City of Plymouth Planning Commission

Regular Meeting Agenda

PULTE HOMES OF MICHIGAN, LLC
 PLYMOUTH MULTI-FAMILY
 AMENDED PRELIMINARY PUD PLAN

Site Plan Review - Amended PUD Plans

PULTE HOMES OF MICHIGAN, LLC PLYMOUTH MULTI-FAMILY AMENDED PRELIMINARY PUD PLAN EXISTING CONDITIONS

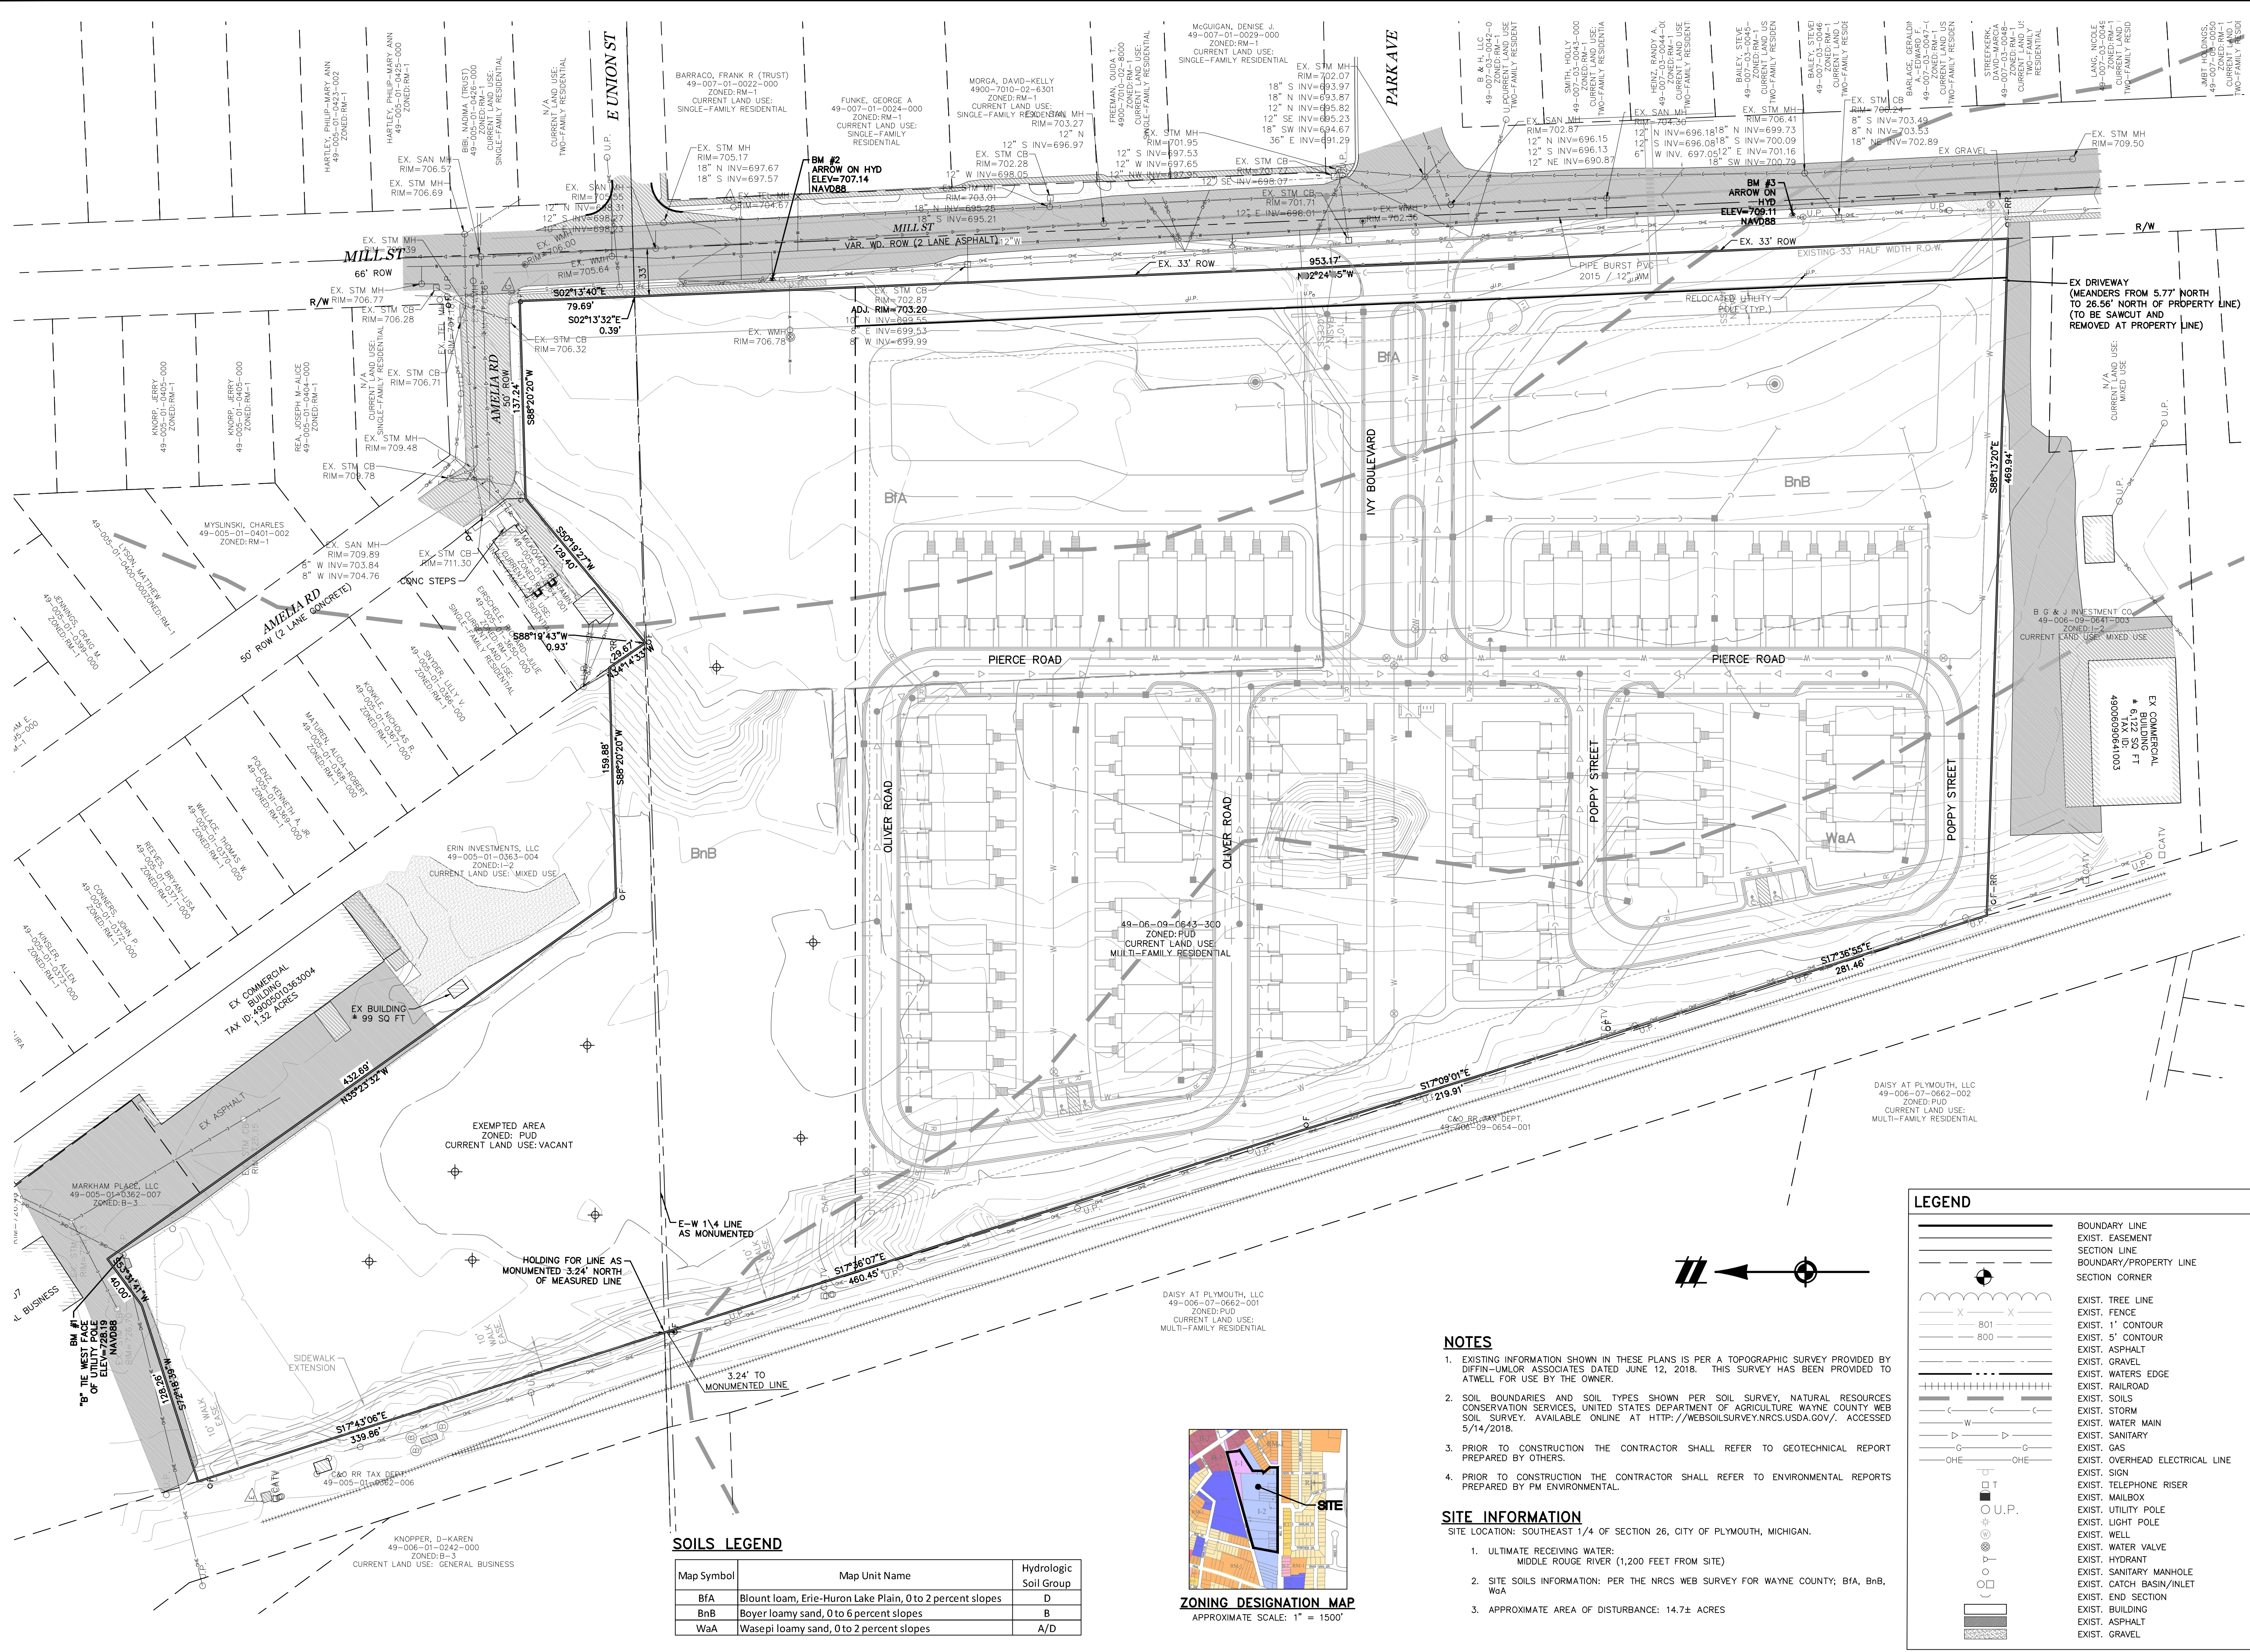
2. Sheet 2, Existing Conditions, needs to be amended to show the following:
 - a. Current zoning of site (PUD) showing “exempted” area. *Provided.*
 - b. Surveyed property lines, and dimensions. A note on this sheet states that the property boundaries are approximate per tax records, and “best fit” GIS records. The ordinance requires accurate information, not approximations. *The applicant states in their narrative that the property boundaries and other information on the sheet are from a field survey, and that this note has been amended to reflect that.*

- c. Actual topography on the northern portion. Again, the plans show “estimated” topography. The ordinance requires accurate information. *See comment in “b” above.*

- d. Actual existing conditions on the southern portion. This sheet shows the southern portion before it was developed. Since this request is amending an existing PUD, accurate information that illustrates the current development, including building locations, roads, sidewalks, and topography, needs to be shown on this sheet to understand the relationship of the current conditions on each portion of the site. Showing it on the grading plan is not sufficient. *The sheet has been amended to show the current conditions (townhome development) on the property to the south, as requested.*

- e. Areas along the north property line of the northern portion are identified with a hatch pattern but are not labeled, and need to be. They appear to be remaining in the proposed layout. Their purpose should also be described. *The narrative explains that these hatch patterns represent existing asphalt and gravel pavement. The hatch patterns have been added to the legend on this sheet.*

The existing conditions plan sheet should be corrected to show the current street names. We believe that the entrance has been named Sydney Boulevard and that the two loops are N. Sydney Ct. and S. Sydney Ct. The existing conditions plan sheet included as part of this submittal shows Ivy Boulevard, Oliver Road, Pierce Road, and Poppy Street. These names should be removed and replaced.

- a. *The previous underlying zoning is I-1 and I-2, as depicted on the zoning map on the cover. The existing zoning (PUD) and a label for the "exempted" area have been added to the existing conditions plan, sheet 2.*
- b. *The property boundary lines shown in the Phase 2 Preliminary PUD plans are field surveyed and measured. The note has been revised accordingly.*
- c. *The topographic survey information shown in the Phase 2 Preliminary PUD area are field surveyed and measured. The note has been revised accordingly.*
- d. *The infrastructure for Phase 1 is currently completed. This has been represented on the existing conditions plan, sheet 2.*
- e. *These hatched areas are existing asphalt and concrete pavements whose hatch patterns have been added to the legend.*

PULTE HOMES OF MICHIGAN, LLC
PLYMOUTH MULTI-FAMILY
AMENDED PRELIMINARY PUD PLAN
LAYOUT PLAN

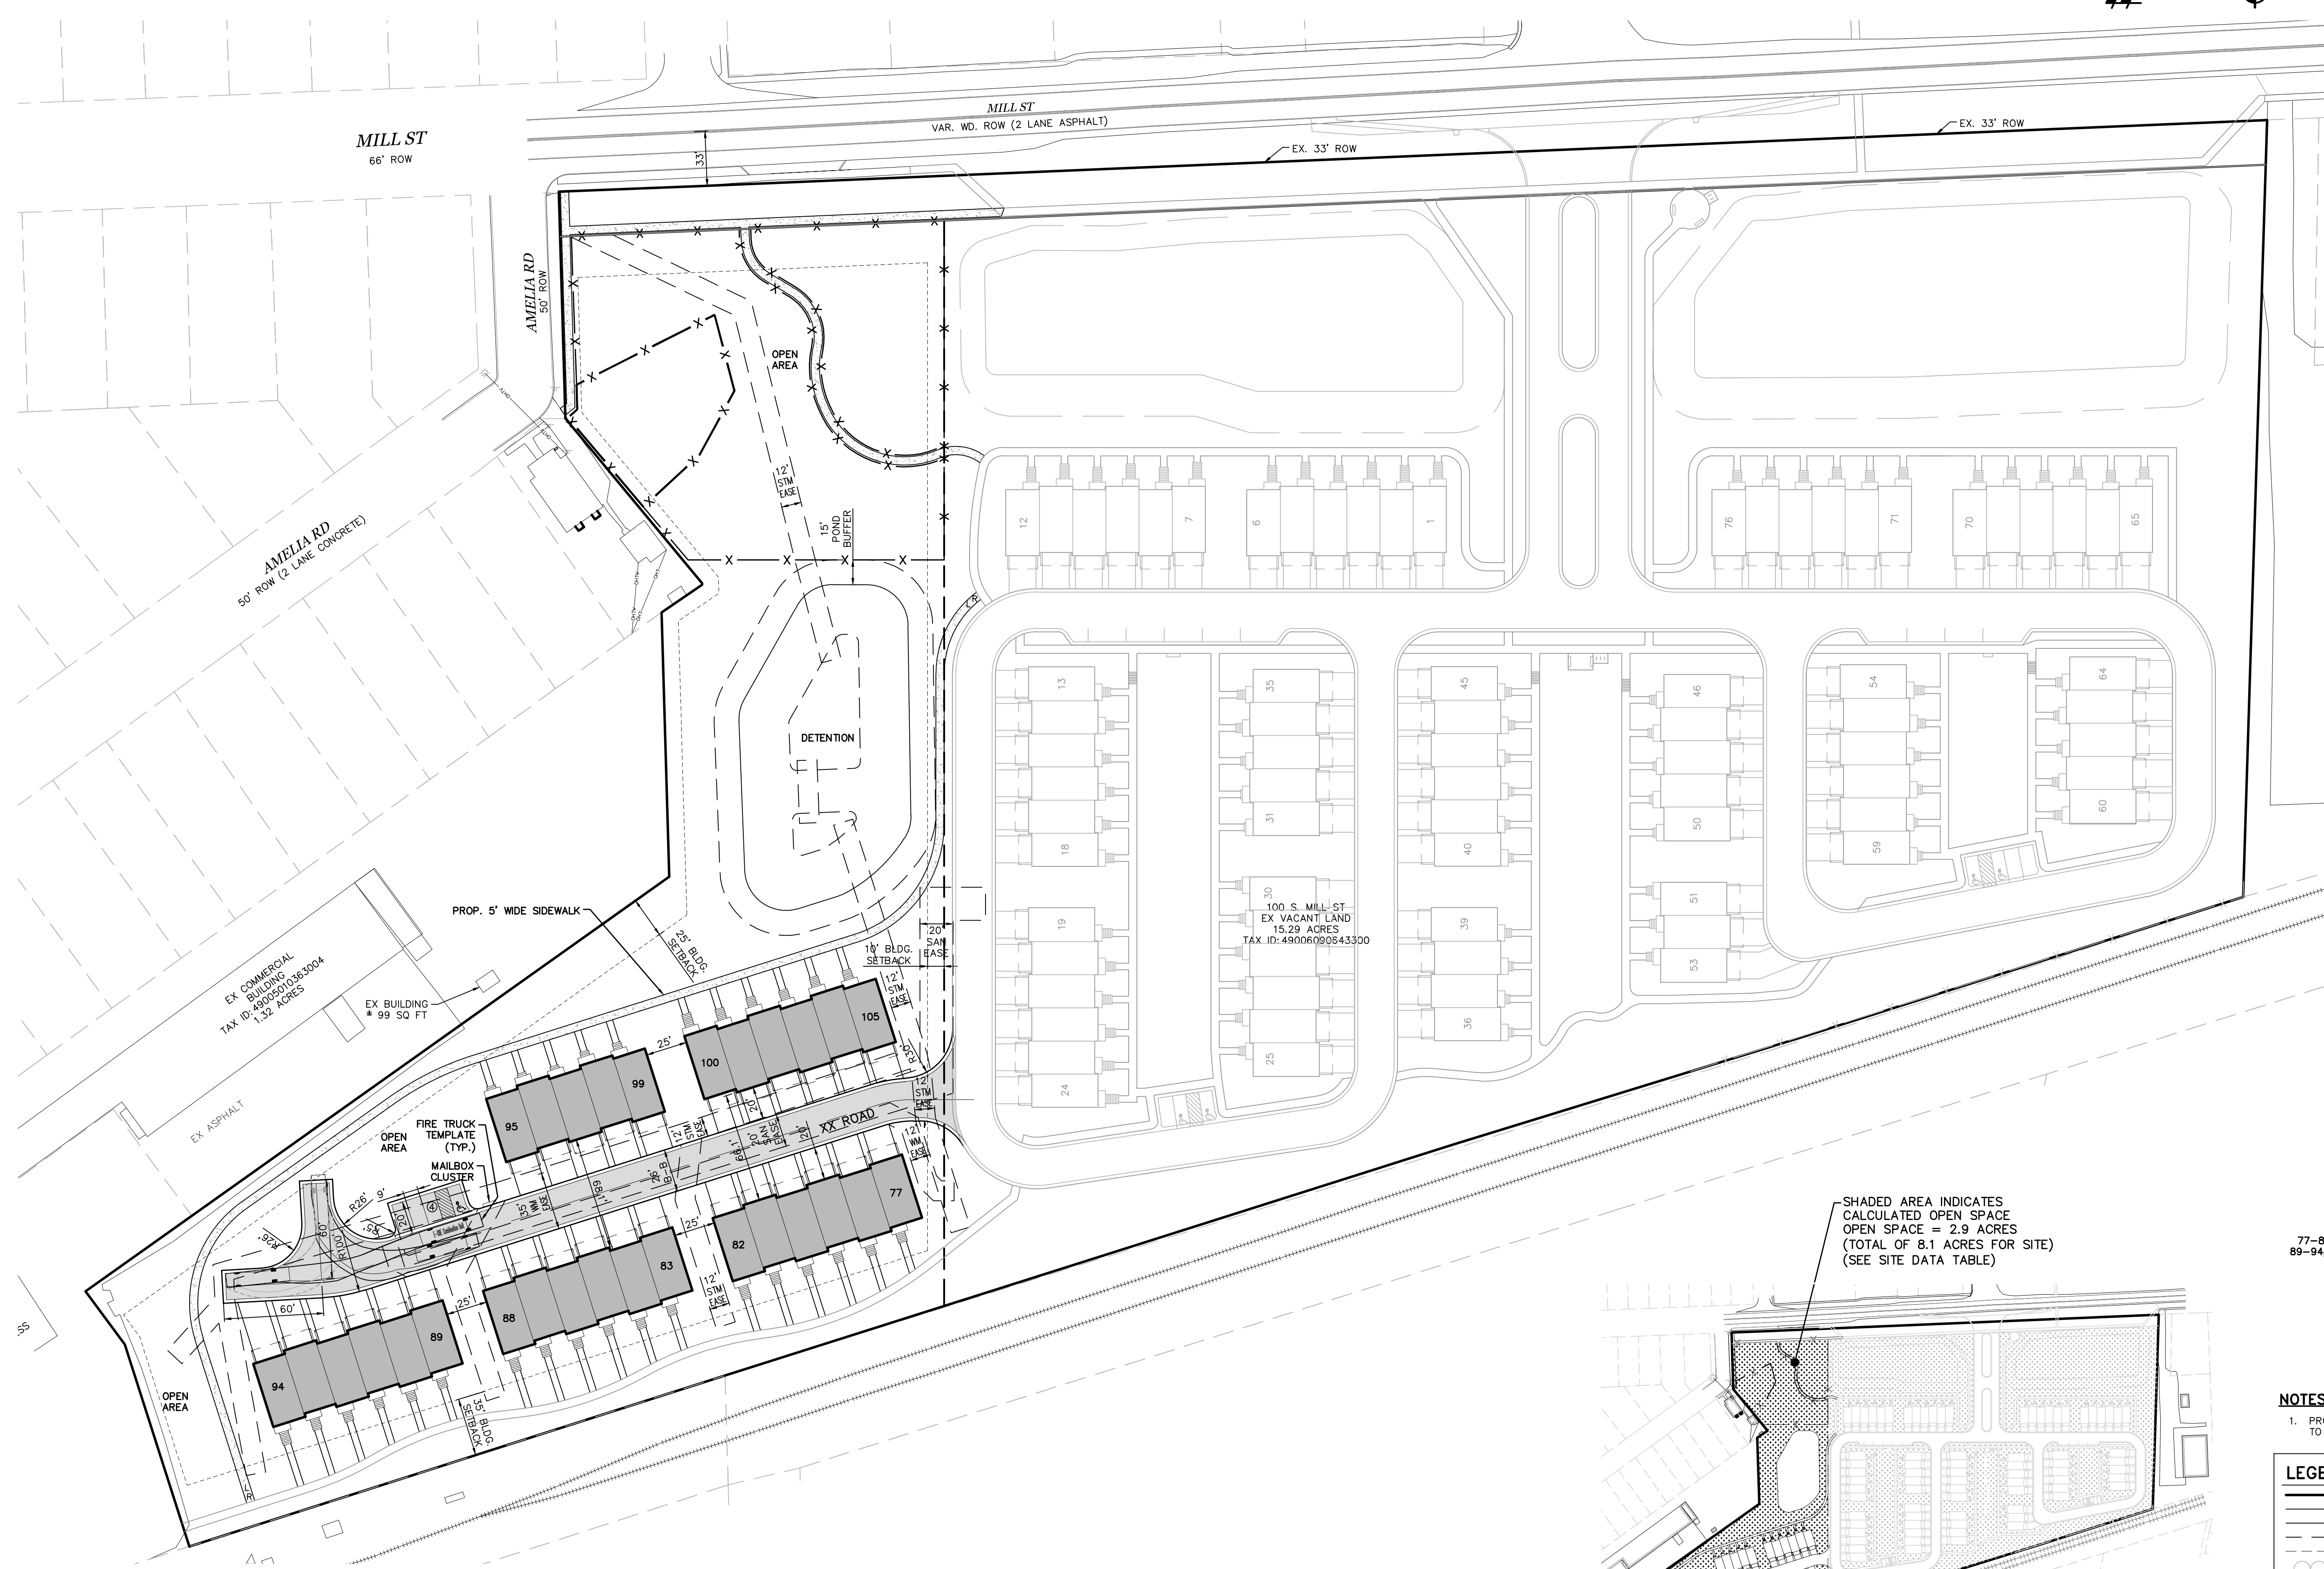
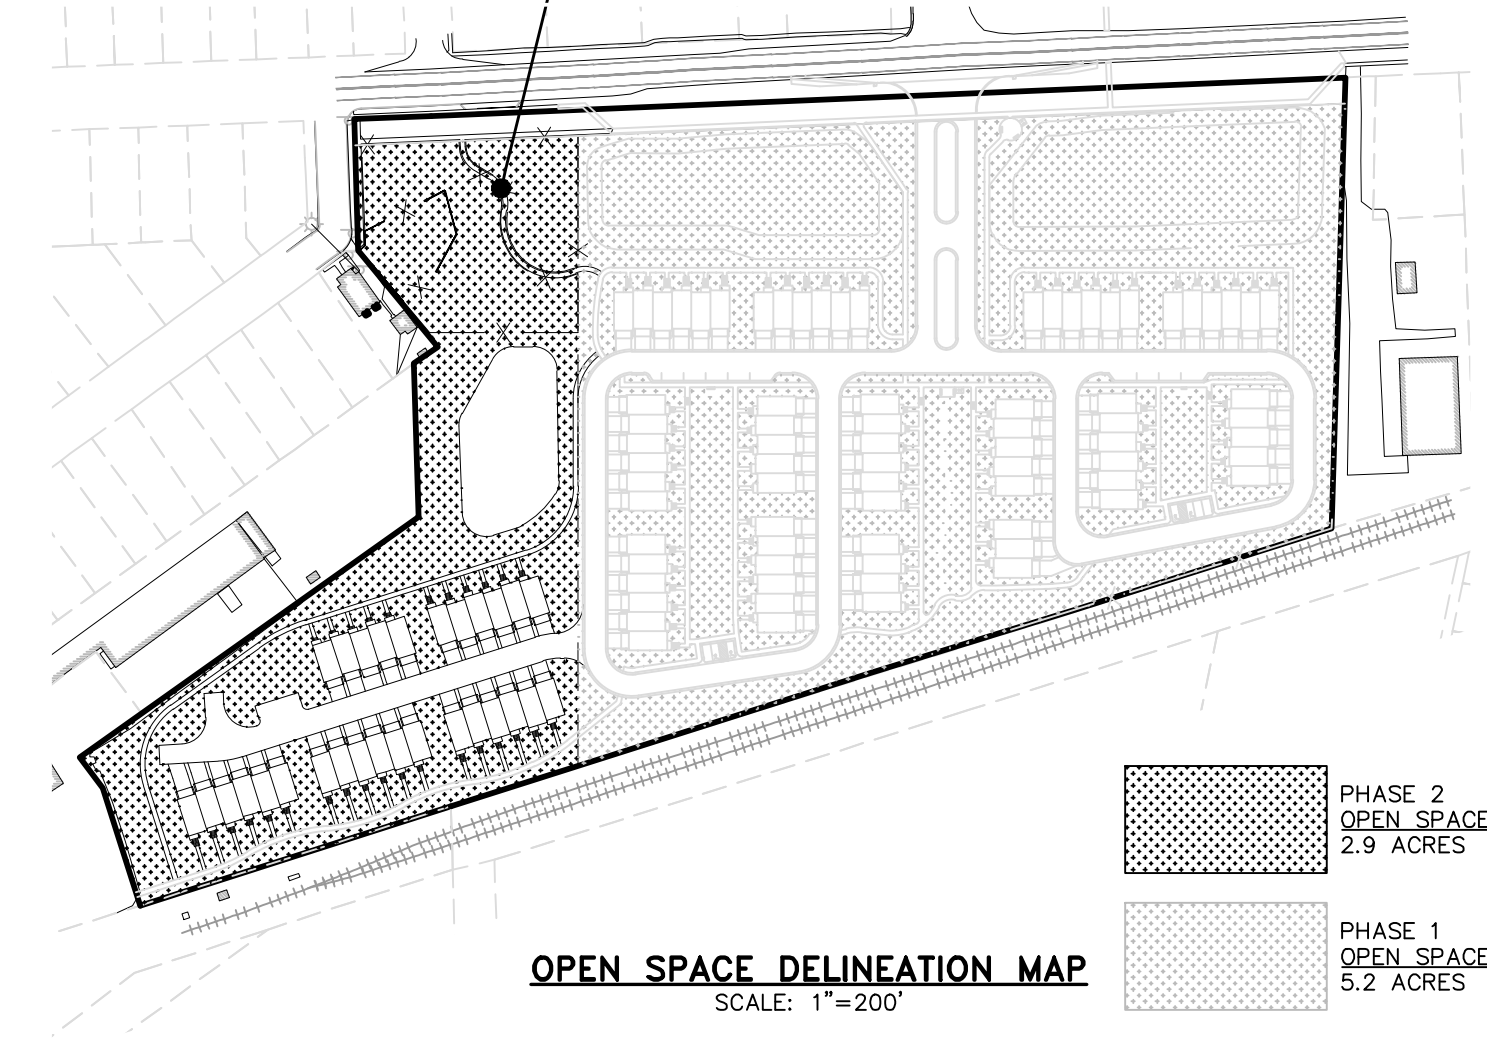
4. Applicant to consider informal looped pathway through mini-park (northern portion).
Response: *A meandering pathway has been added.*
5. Applicant to describe why new a sidewalk is not proposed in the new Mill St. right-of-way on the northern portion, similar to the southern portion.

Response: *The walk is now shown to be relocated, similar to the original development.*
6. City Engineer to confirm capacity in City water and sewer systems to accommodate this development.

Response: *Confirmed.*
11. Add one barrier-free space in visitor parking area.
Response: *An additional barrier-free guest parking space is now shown, as requested.*

The applicant's description of open space (Sheet 3) states that this portion of the site will offer an additional 2.9 acres of open space, in addition to the 5.2 acres on the southern portion of the site.

These plans show that the Mill St. right-of-way will be widened, occupying approximately 230 lineal feet across the northern portion of the site. The plans have been modified to shift the sidewalk approximately 30-feet away from the Mill St. travel lanes and in line with the new sidewalk across the townhome development to the south. We consider this a positive change to the plans.
